233/25 Wentworth Street, Manly

NSW Department of Planning & Infrastructure
22-33 Bridge Street
Sydney NSW 2000

Name of application: Royal Far West Expansion Concept Plan
South Steyne and Wentworth Street, Manly
Application number: MP10_0159

Current view from Living Area

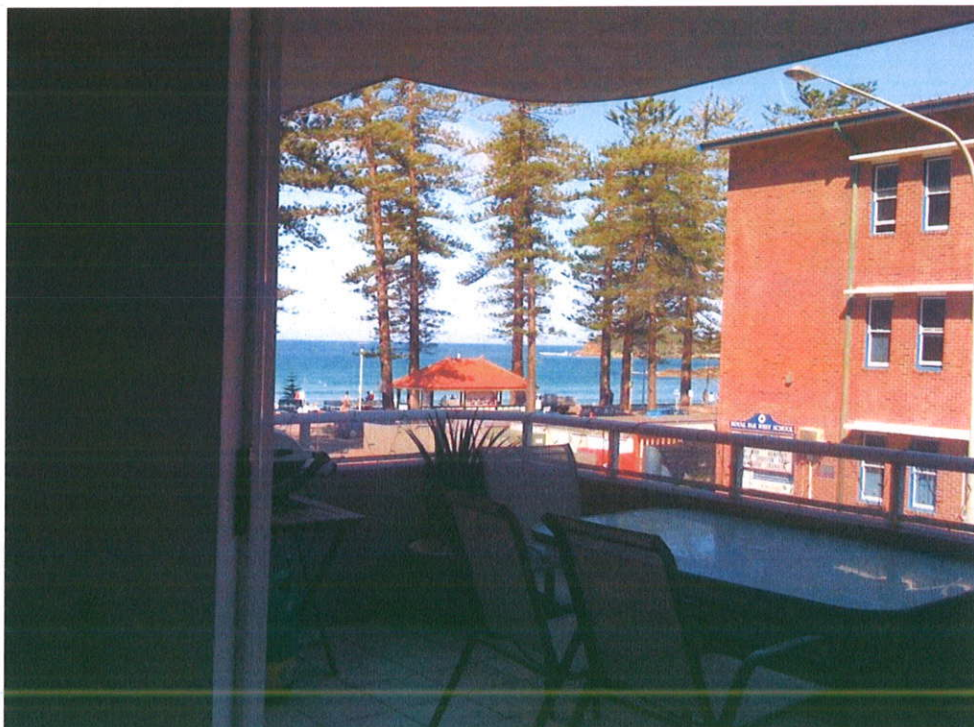
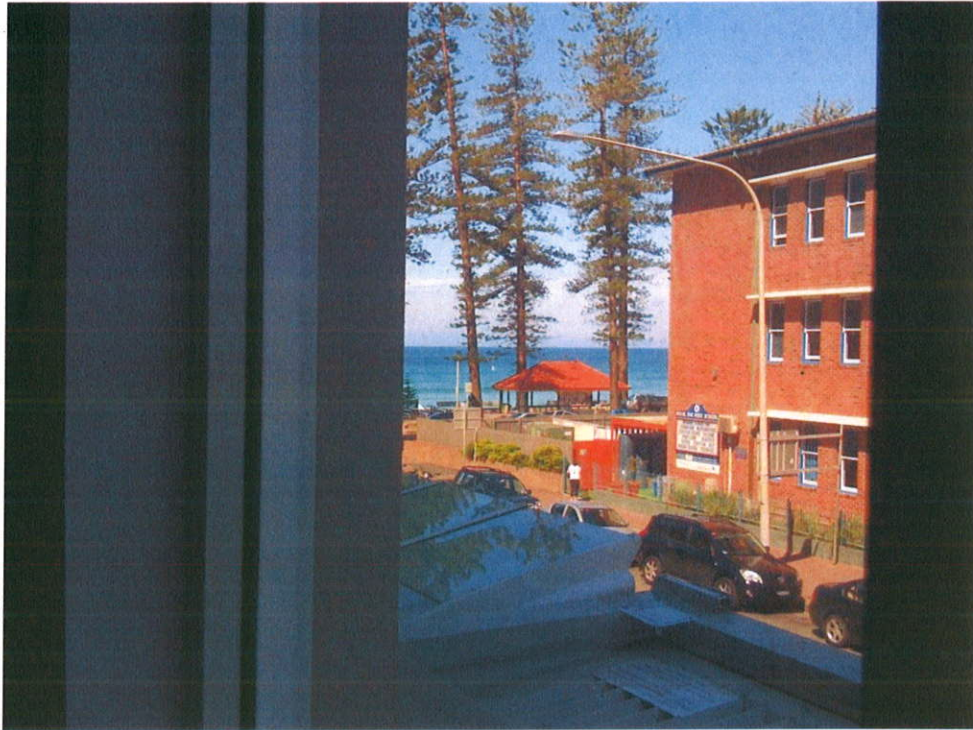
View after Proposed RFW Development

Current view from Bedroom 2

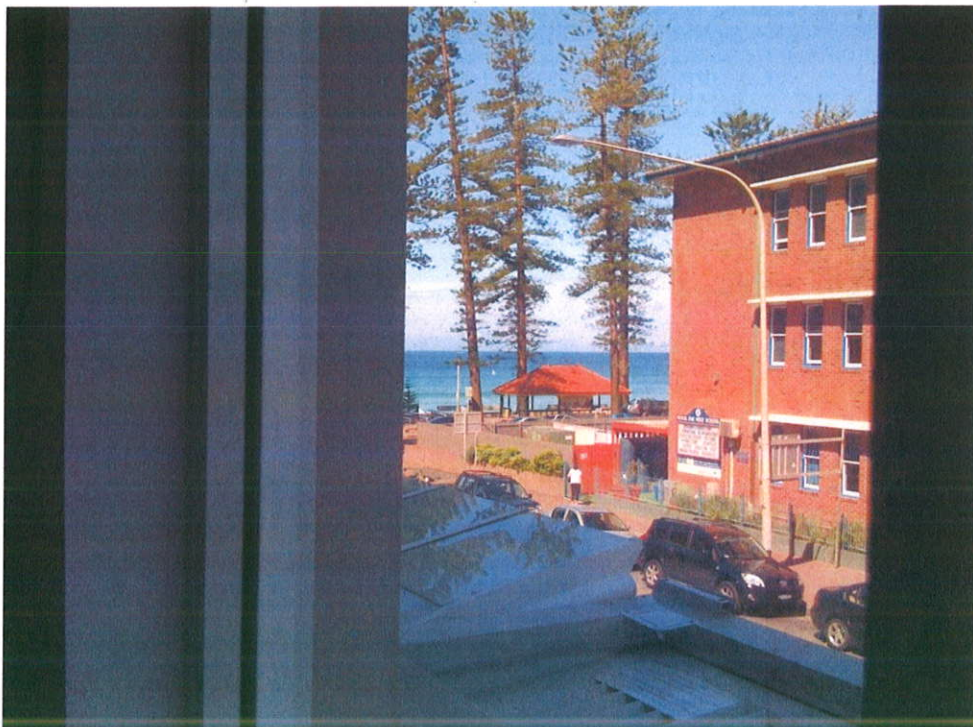
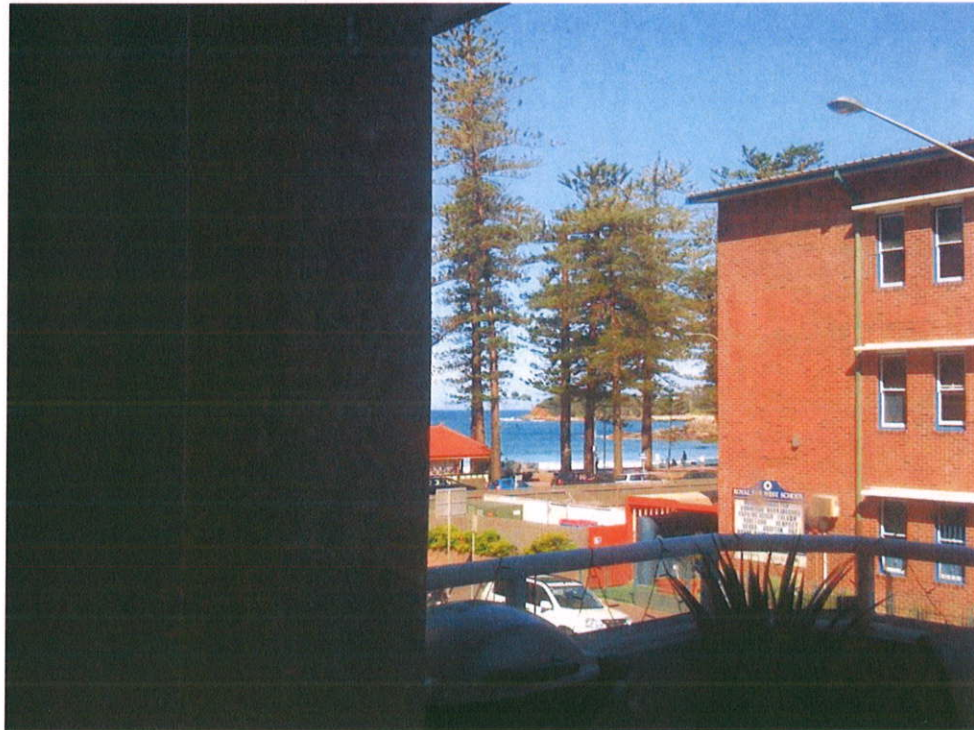
View after Proposed RFW Development

Current view from Balcony

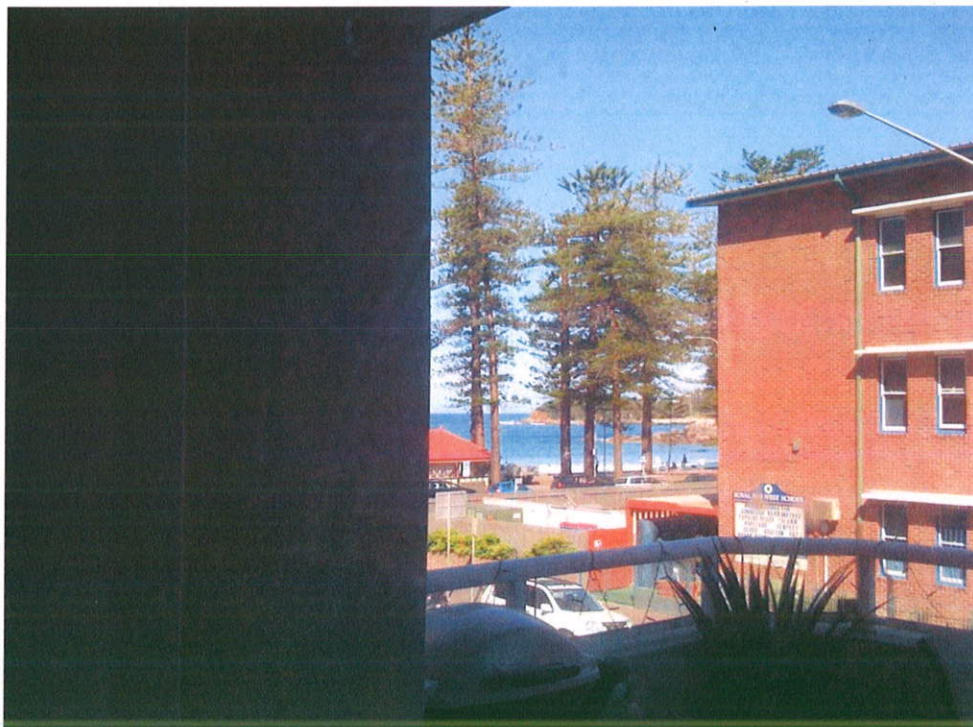
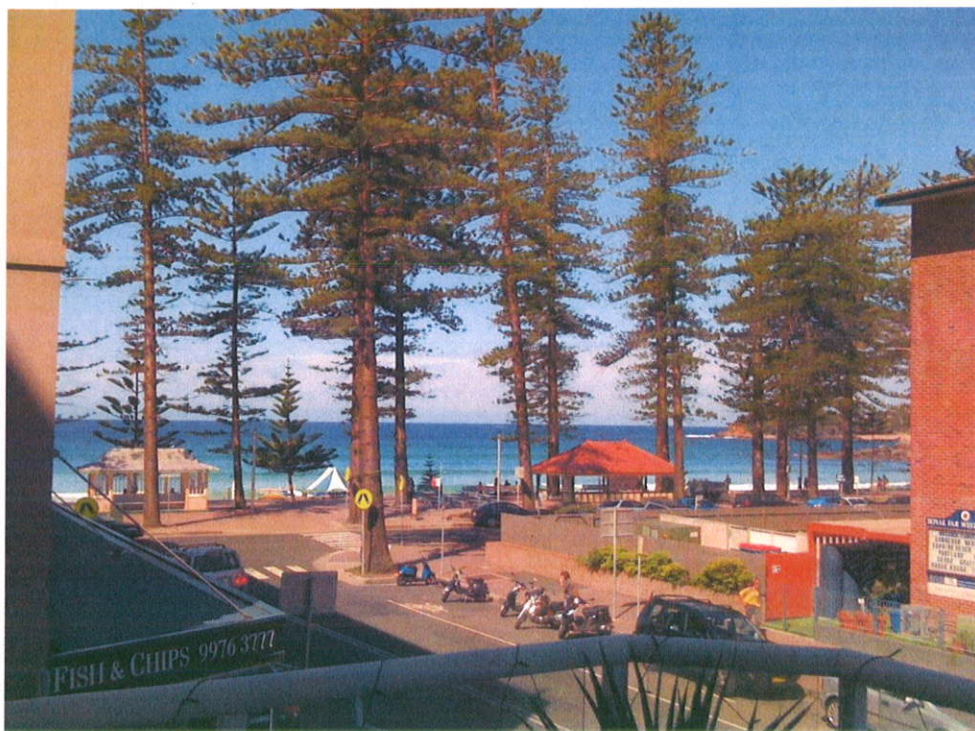
View after Proposed RFW Development

Current view from Bedroom 3

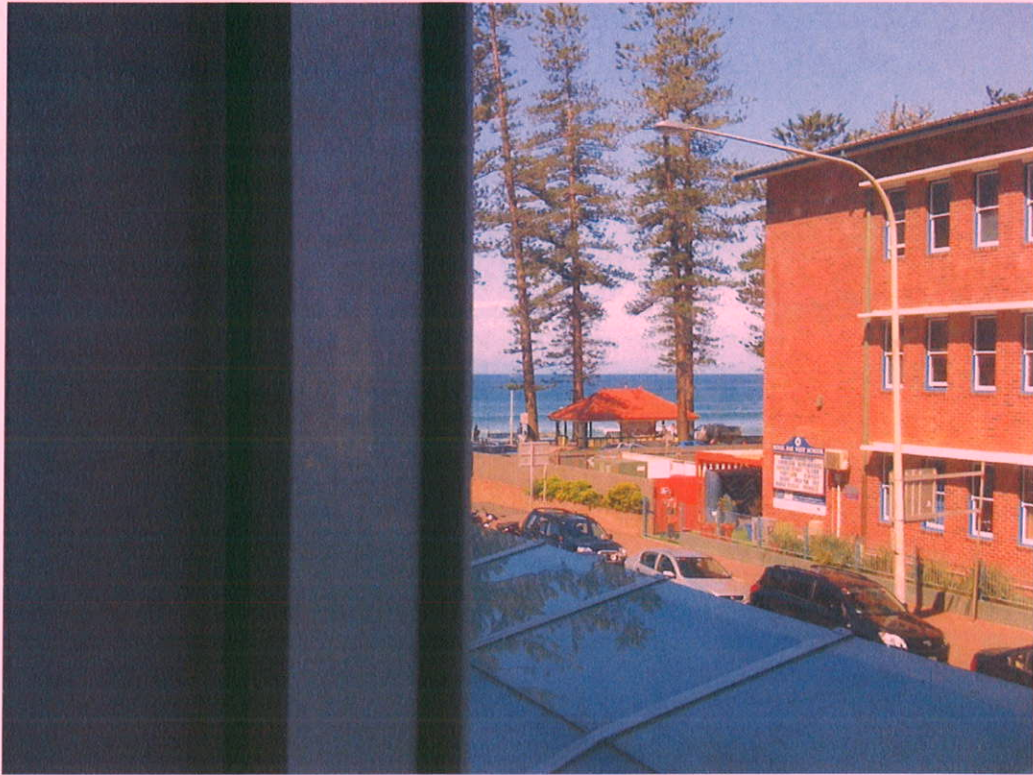
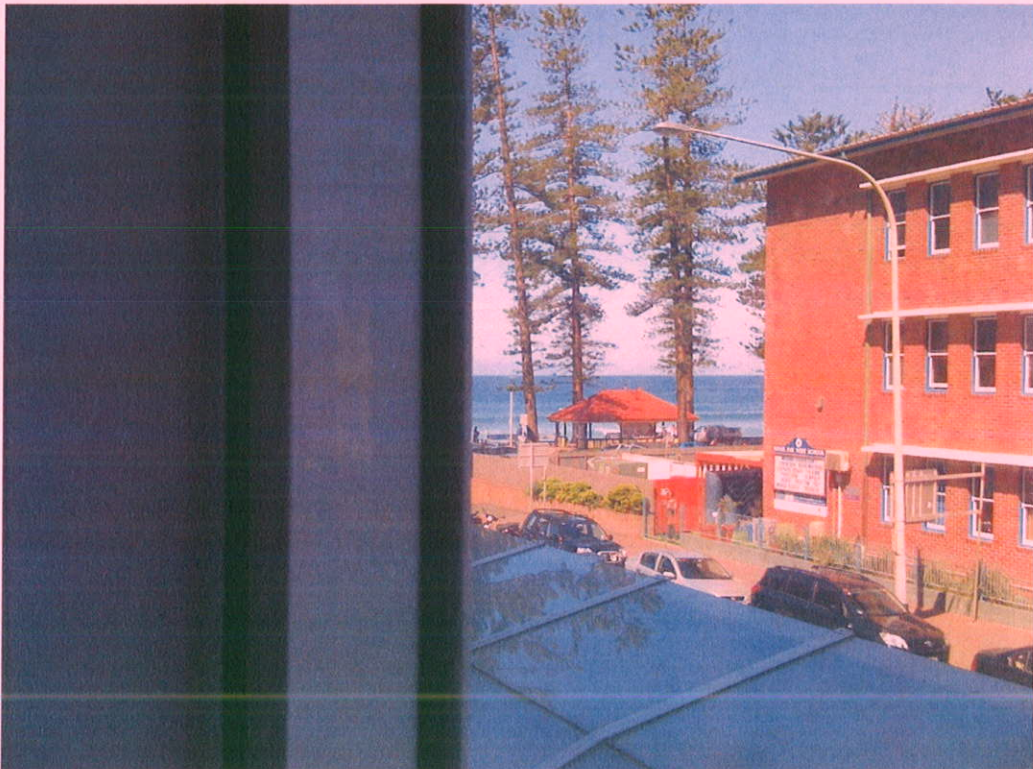
View after Proposed RFW Development
